northern beaches council
PLANS APPROVED BY THE LAND AND ENVIRONMENT COURT OF NSW
PROCEEDINGS NO: 2023/238892
DATED: 5 June 2024

FOR S4.55 (8) APPLICATION

PROJECT:
PROPOSED SENIORS LIVING
4 ALEXANDER ST, COLLAROY
NSW

1 Site Plan
1 : 150@A1

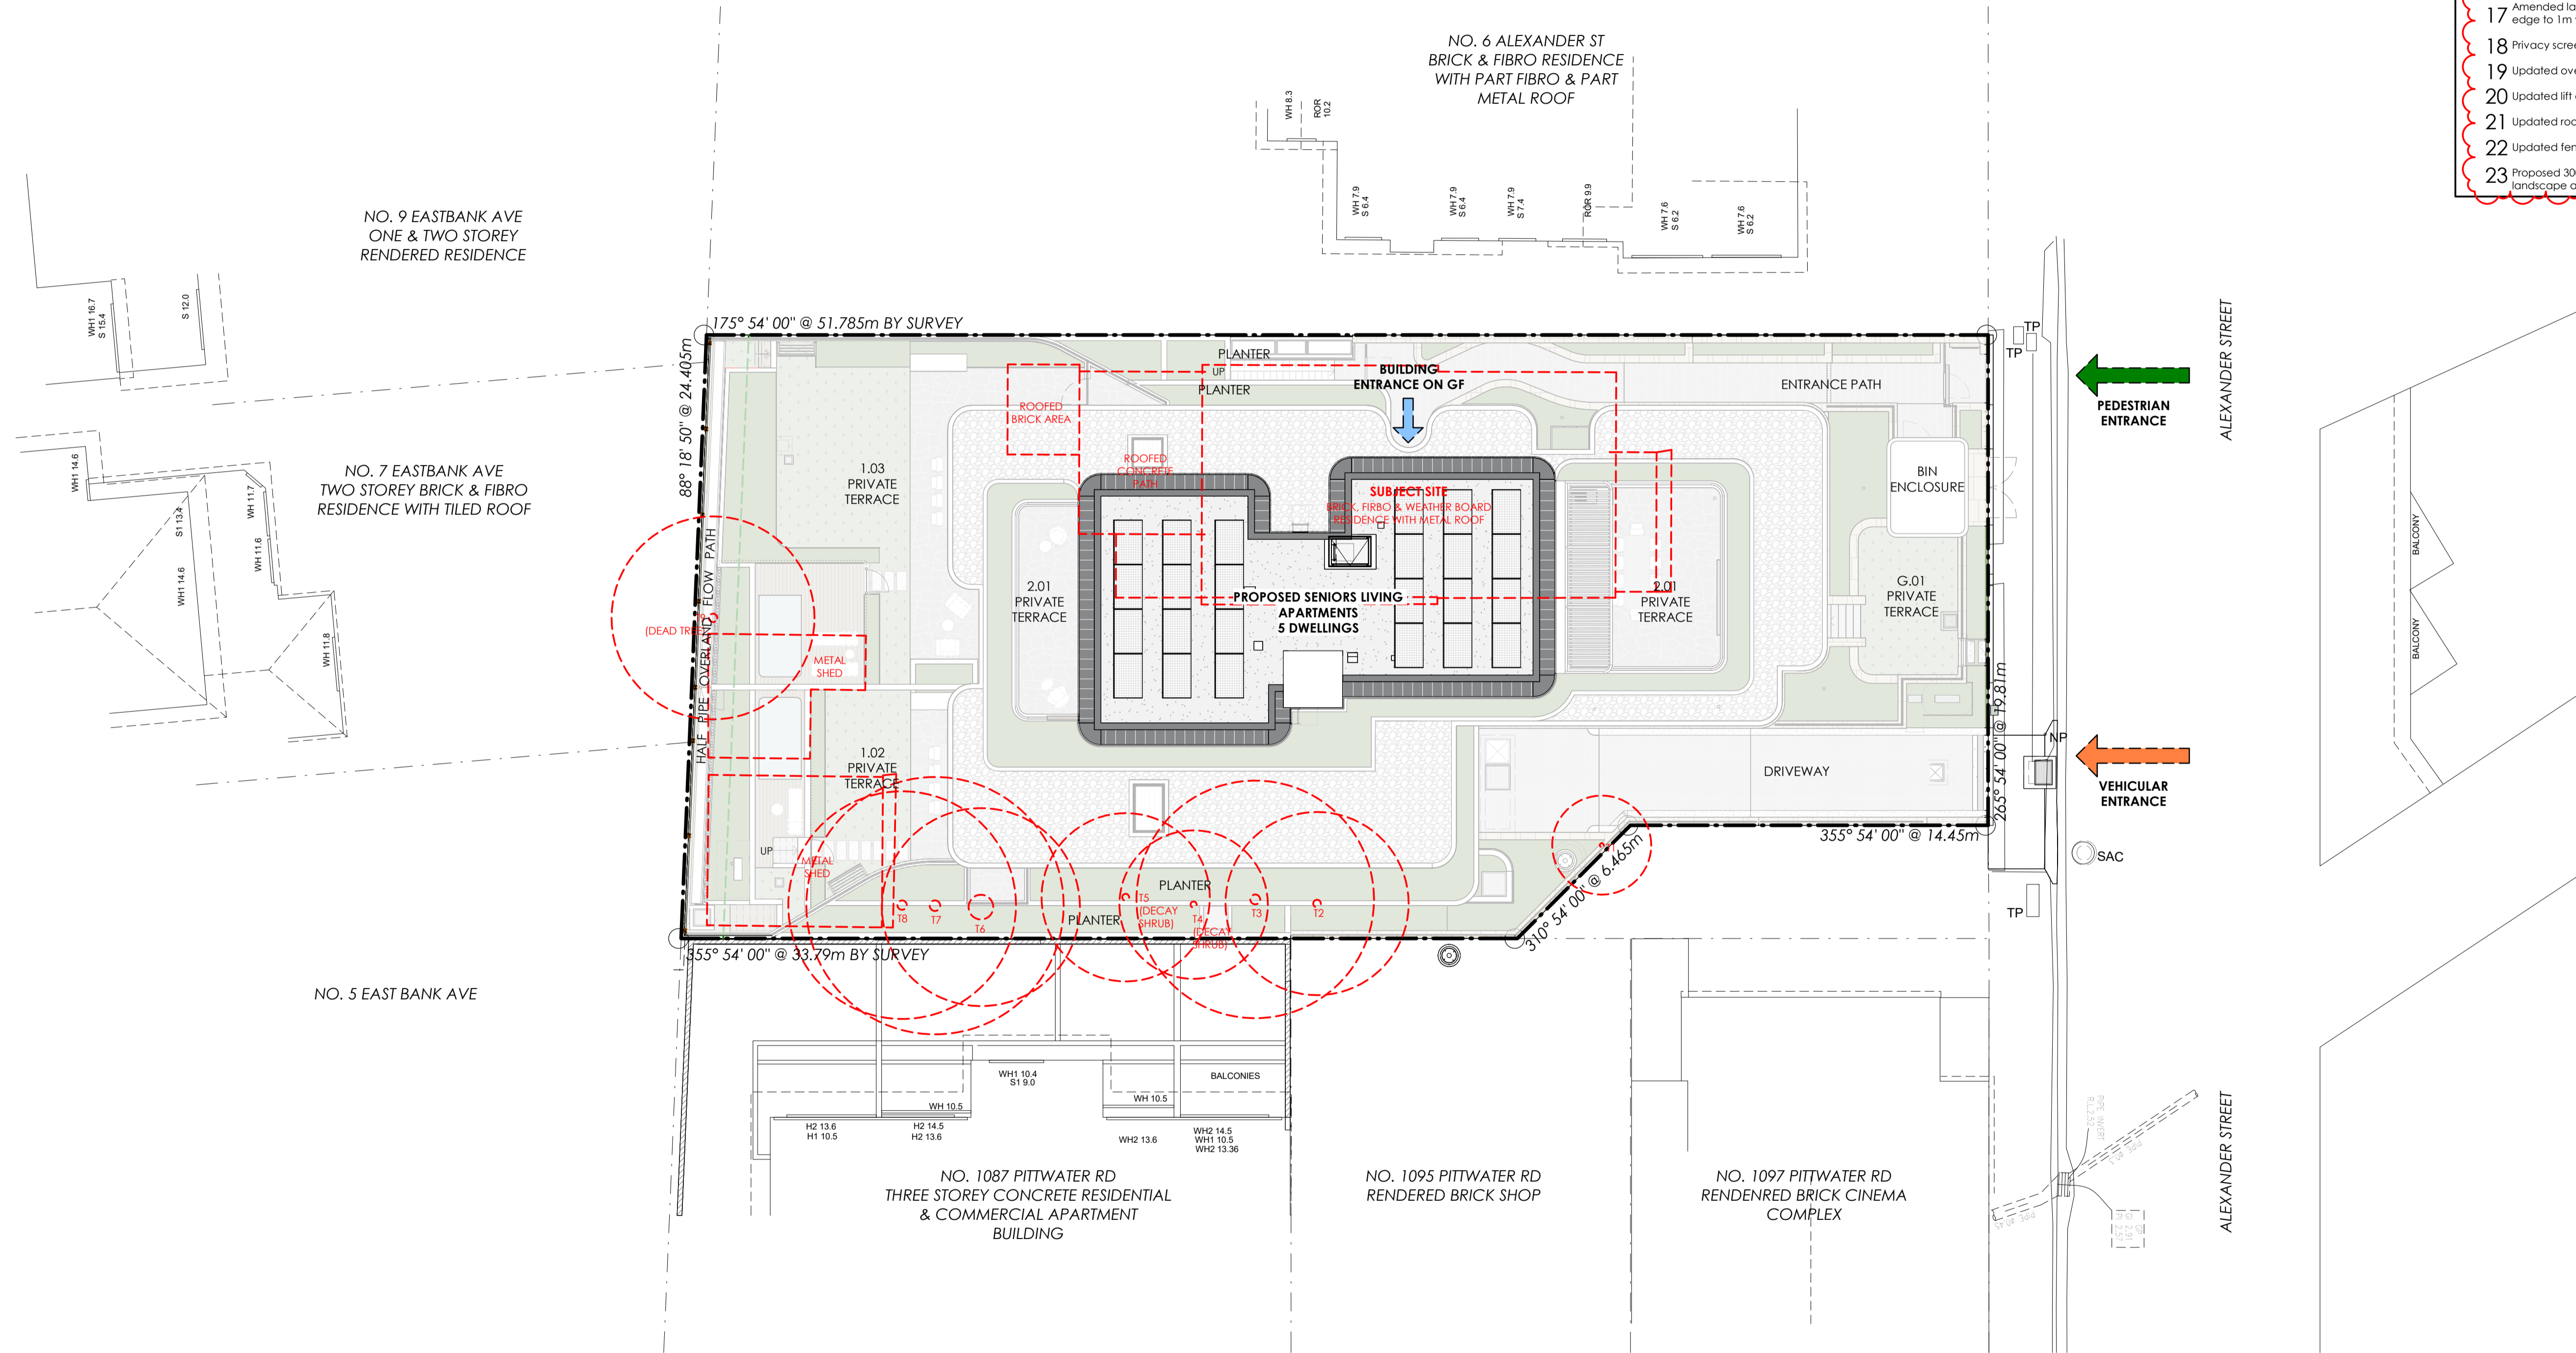
- Proposed modifications to skylights including deletion of 2 skylights over unit 2.01, and updated sizes of skylights over Unit 1.02 & 1.03.
- Additional storage room at basement level.

- Updated interior layout generally.
- Modification to facade windows openings and configurations generally.
- Additional metal framed louvre awning to Level 2.

- Proposed removal of flood gate from driveway and associated DA Condition 28.
- Proposed external design modifications including additional BBQ benches, planters, fences and gates for maintenance access to side planters at rear (Level 1).

- Updated stormwater concept design.
- Associated landscape design update including:
 - a) Level 1: proposed updated overland flow path based on civil eng.'s assessment

- b) Level 1: proposed 2 additional private plunge pools at rear
 - c) Level 1: Revised boundary fencing height and design at rear
 - d) Level 1: Revised external levels

- e) Level 1: Revised external backyard
 - f) Ground floor: Revised front garden design to G.01 and around OSD tank area
- Proposed building height increase including adjustments to floor levels to:

- Level 1: RL 7.73
 - Level 2: RL 11.03
 - Roof: RL 14.25
- Updated roof layout including adjustment to lift overrun structure, services layout and photovoltaic panels. Proposed deletion of DA Condition 8 as part of the proposed amendments at roof level.

- Updated extent of shoring and retention generally.
- Modification to proposed car parking arrangement and number of car space.
- Adjustment to level 2 envelope shifting towards west generally.

- Frosted glazing to level 2 ensuite window
- Proposed removal of topmost roof overhang and revision to the perimeter parapet detail.
- Amended landscape design at level 2 including additional planters and increase southern edge to 1m width.

- Privacy screen to eastern edge of level 2 balcony at rear.
- Updated overland flow path design.
- Updated lift overrun level.
- Updated roof layout to relocate AC units to lower levels.

- Updated fence height to southern boundary
- Proposed 300mm shoring wall setback from boundary with additional planters to landscape architect's details

DA050
BASEMENT PLAN

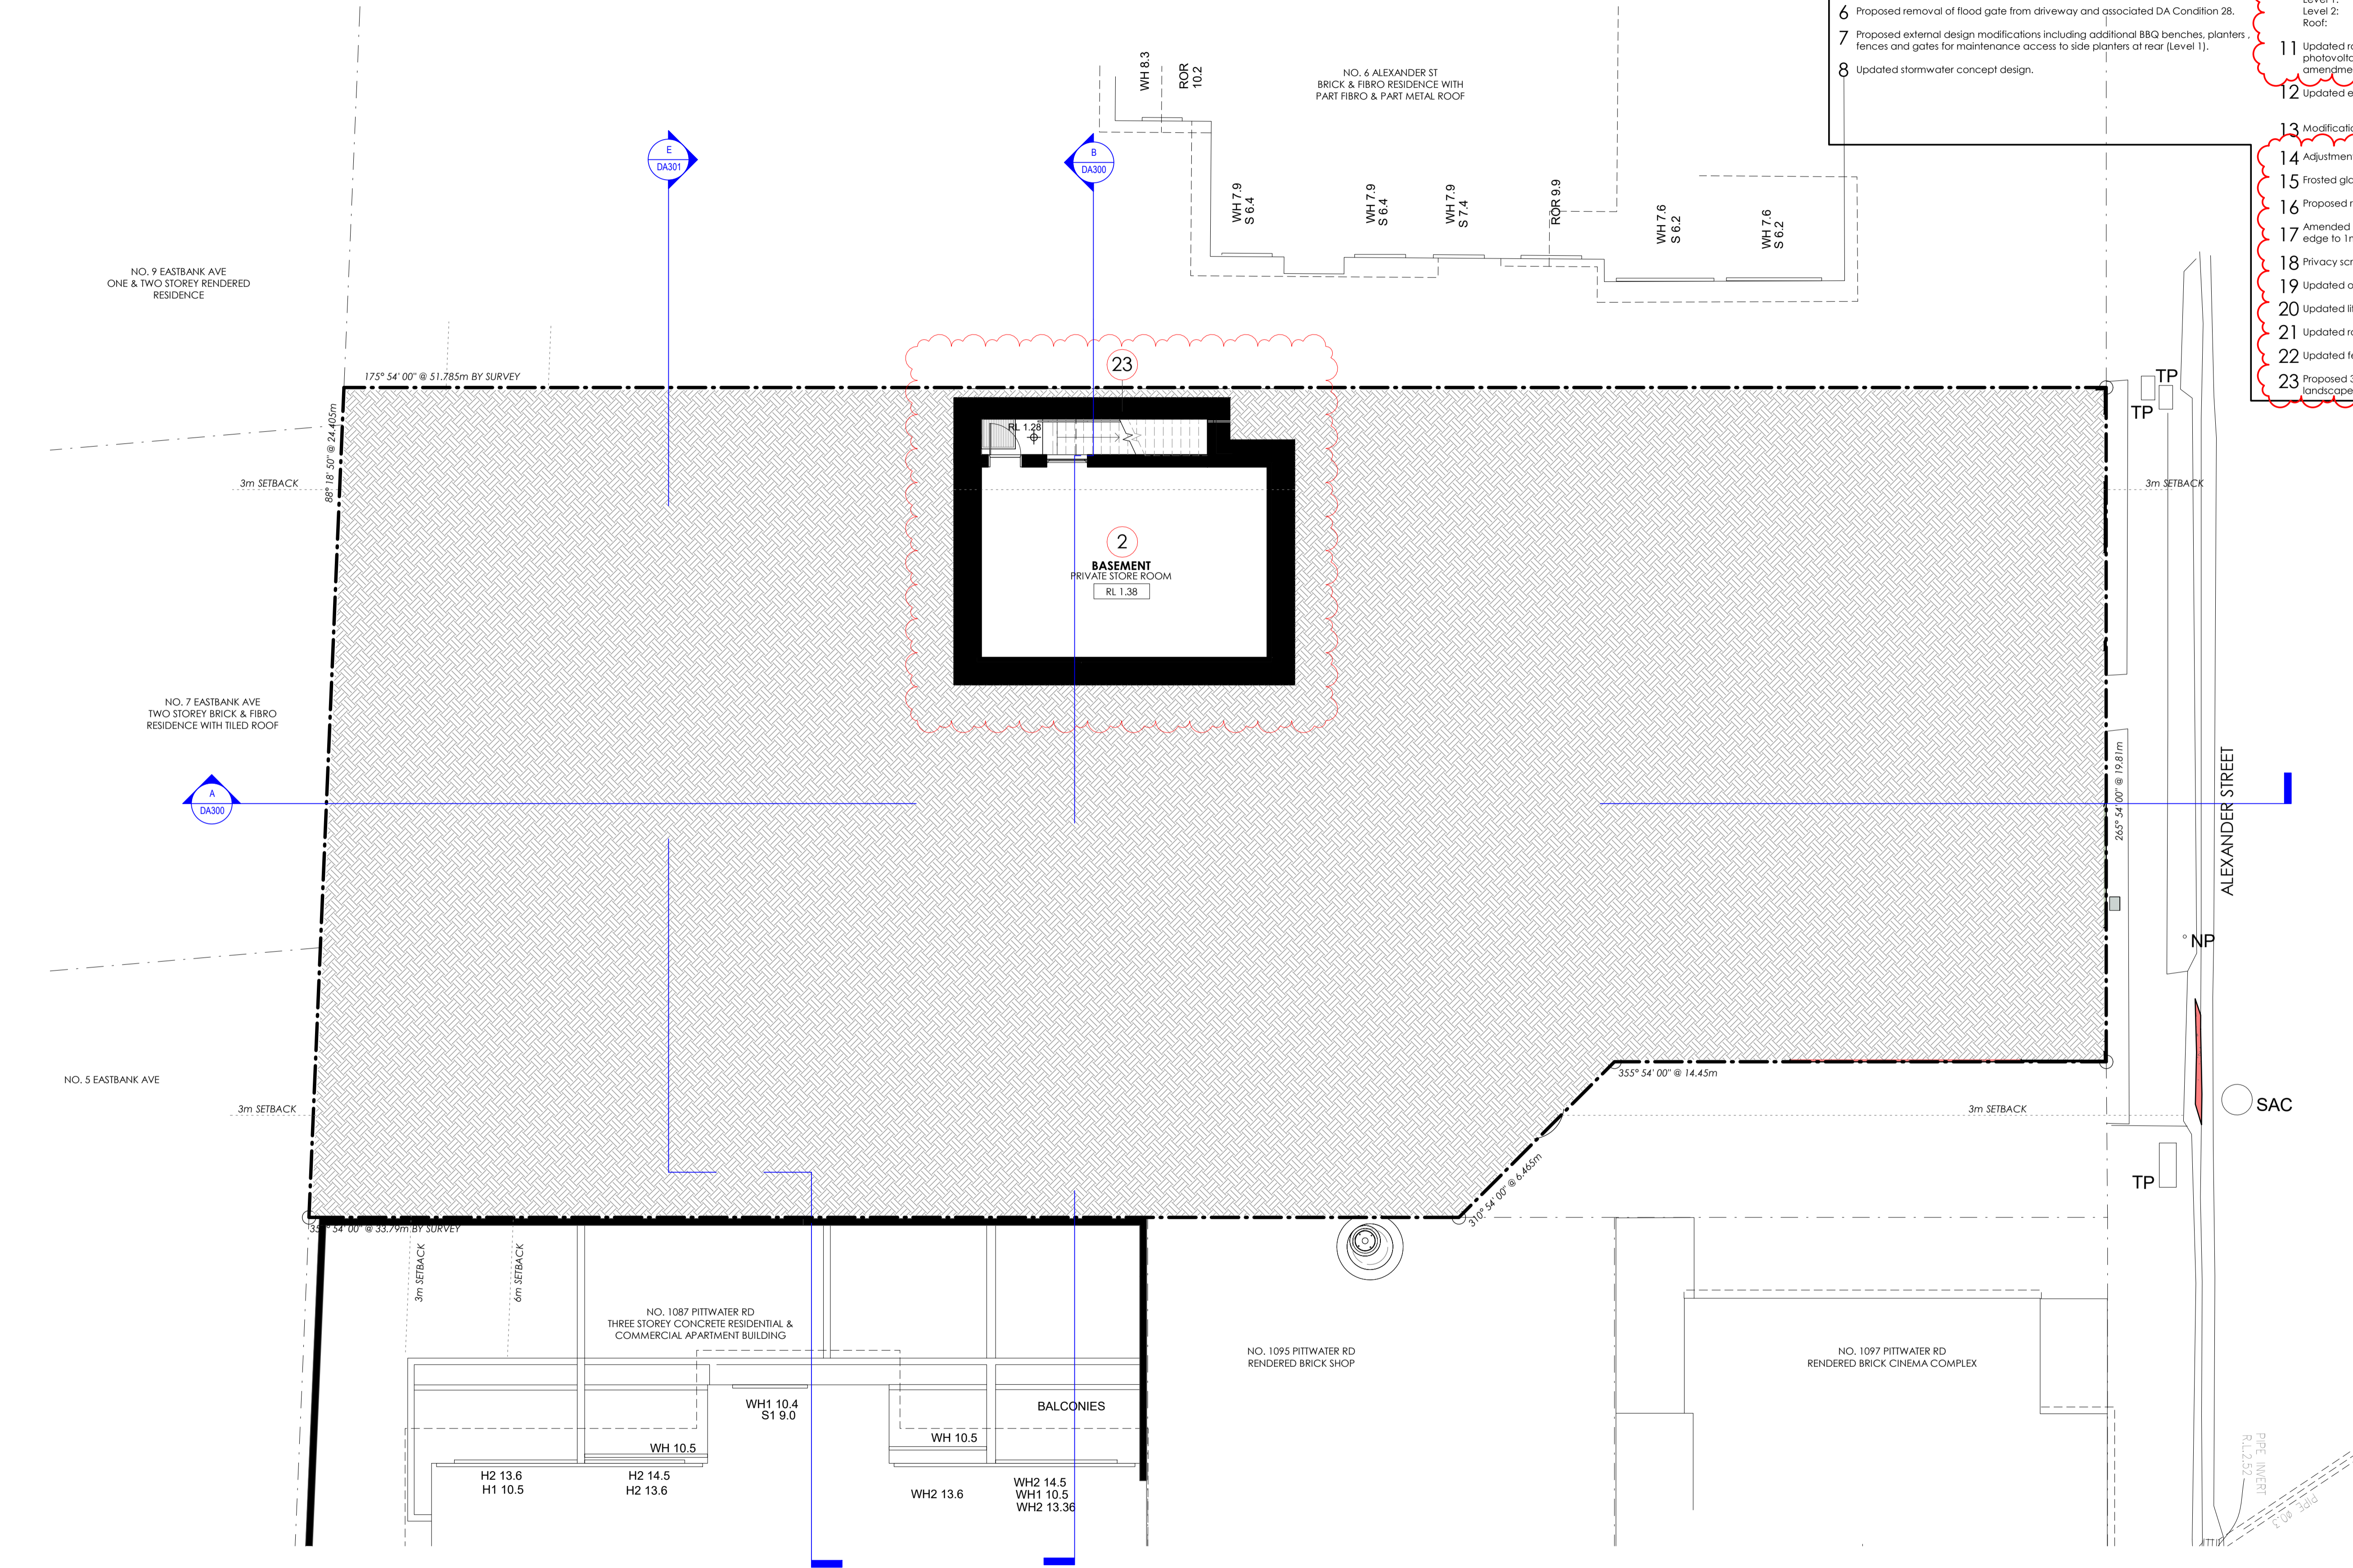
- Proposed modifications to skylights including deletion of 2 skylights over unit 2.01, and updated sizes of skylights over Unit 1.02 & 1.03.
- Additional storage room at basement level.
- Updated interior layout generally.
- Modification to facade windows openings and configurations generally.
- Additional metal framed louvre awning to Level 2.
- Proposed removal of flood gate from driveway and associated DA Condition 28.
- Proposed external design modifications including additional BBQ benches, planters, fences and gates for maintenance access to side planters at rear (Level 1).
- Updated stormwater concept design.

- Associated landscape design update including:
 - a) Level 1: proposed updated overland flow path based on civil eng.'s assessment
 - b) Level 1: proposed 2 additional private plunge pools at rear
 - c) Level 1: Revised boundary fencing height and design at rear
 - d) Level 1: Revised external levels
 - e) Level 1: Revised external backyard
 - f) Ground floor: Revised front garden design to G.01 and around OSD tank area
- Proposed building height increase including adjustments to floor levels to:
 - Level 1: RL 7.73
 - Level 2: RL 11.03
 - Roof: RL 14.25
- Updated roof layout including adjustment to lift overrun structure, services layout and photovoltaic panels. Proposed deletion of DA Condition 8 as part of the proposed amendments at roof level.
- Updated extent of shoring and retention generally.

- Modification to proposed car parking arrangement and number of car space.
- Adjustment to level 2 envelope shifting towards west generally.
- Frosted glazing to level 2 ensuite window
- Proposed removal of topmost roof overhang and revision to the perimeter parapet detail.
- Amended landscape design at level 2 including additional planters and increase southern edge to 1m width.
- Privacy screen to eastern edge of level 2 balcony at rear.
- Updated overland flow path design.
- Updated lift overrun level.
- Updated roof layout to relocate AC units to lower levels.
- Updated fence height to southern boundary
- Proposed 300mm shoring wall setback from boundary with additional planters to landscape architect's details
